APPLICATION NO.	FILING DATE	FIRST NAMED INVENTOR	ATTORNEY DOCKET NO.	CONFIRMATION NO.
10/617,115	07/10/2003	Han-Lim Lee	5000-1-381	2604
33942	7590	04/15/2005	EXAMINER	
CHA & REITER, LLC 210 ROUTE 4 EAST STE 103 PARAMUS, NJ 07652			SONG, SARAH U	
			ART UNIT	PAPER NUMBER
			2874	
DATE MAILED: 04/15/2005

Office Action Summary	Application No.	Applicant(s)	
	10/617,115	LEE ET AL.	
	Examiner	Art Unit	
	Sarah Song	2874

DETAILED ACTION

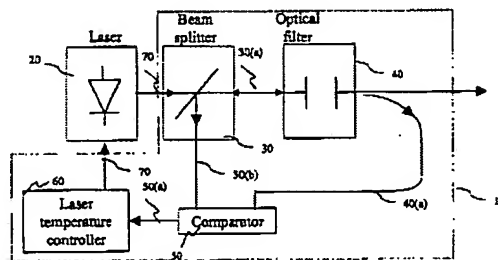
5. Regarding claim 1, Peral et al. discloses an optical transmitter for converting signals into optical signals and transmitting the optical signals using optical fibers, the optical transmitter comprising:

- an electric signal generator 50 to convert a received signal into an electric signal;
- a distributed feedback laser diode 20 to convert an electric signal into an optical signal;

- and an optical filter 40 configured to filter the optical signal using a central wavelength corresponding to '1' level of the optical signals, perform a vestigial side band modulation of the optical signal by degenerating a determined band of the optical signal using the central wavelength, and reduce the power of '0' level of the optical signals.

See Paragraphs [0021] and [0023]; Figures 2a, 2b and 2c.

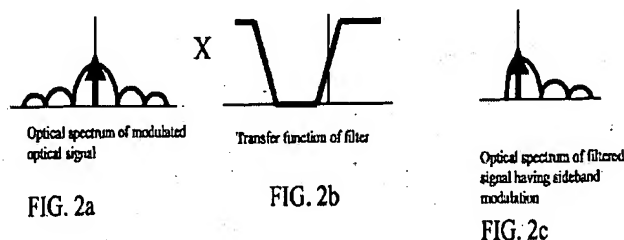
7. Onaka et al. discloses an optical tunable filter 18 for maintaining the desired filtering characteristics (see column 6, lines 28-31).

9. Therefore, it would have been obvious to one having ordinary skill in the art at the time the invention was made to provide an optical tunable filter as disclosed by Onaka et al. in the device of Peral et al.

10. One of ordinary skill in the art would have been motivated to provide a tunable filter in order to ensure operational stability of the optical filter 40 and to preserve the optimum characteristics of the filter.
